Air Resources Board

April 24, 2002

#02-05

Thank you for your letter dated March 25, 2002 requesting California Air Resources Board (CARB) approval of a modification to a spill container designed for use with Phase I vapor recovery systems installed in secondary containment sumps. The modification involves a new method of securing the upper section of the spill container to the lid ring, which is bolted to the manhole cover. The upper section of the spill container consists of a flexible bellows made of rubber. The previous design used an expansion ring with a single adjustment screw to secure the bellows to the manhole ring. The new design uses a three-piece compression ring and six bolts to secure the bellows to the manhole ring.

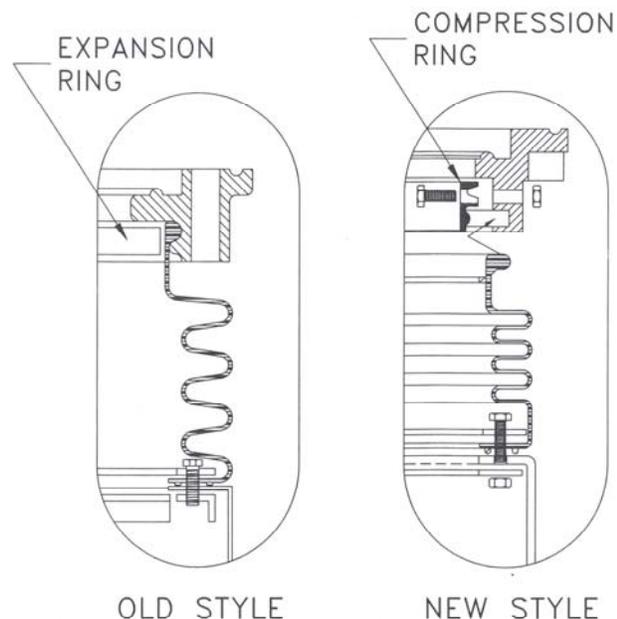
CARB has reviewed the drawings and conducted visual inspections of an installation and has determined that the drain valve has not been modified. CARB has also inspected the new spill container as installed to verify that the new design does not adversely affect the vapor adaptor or any other vapor recovery component. Since the requested modification you described seems to relate only to the issue of standing fuel, the modification is approved under the following conditions:

- 1) The modification does not impact vapor recovery system and is approved under CP-201 section 19 only as a replacement part that does not meet the requirements of CP-201 section 3 (EVR for phase I systems).

- 2) The modified spill container is certified as a replacement part only through April 2005. The modification is approved for non-EVR replacements/retrofits only.
- 3) The spill container is not certified for use in new installations of Phase I EVR systems.
- 4) CARB approval of the modification does not constitute approval for the Water Resources Control Board or approval as required by any other agency.
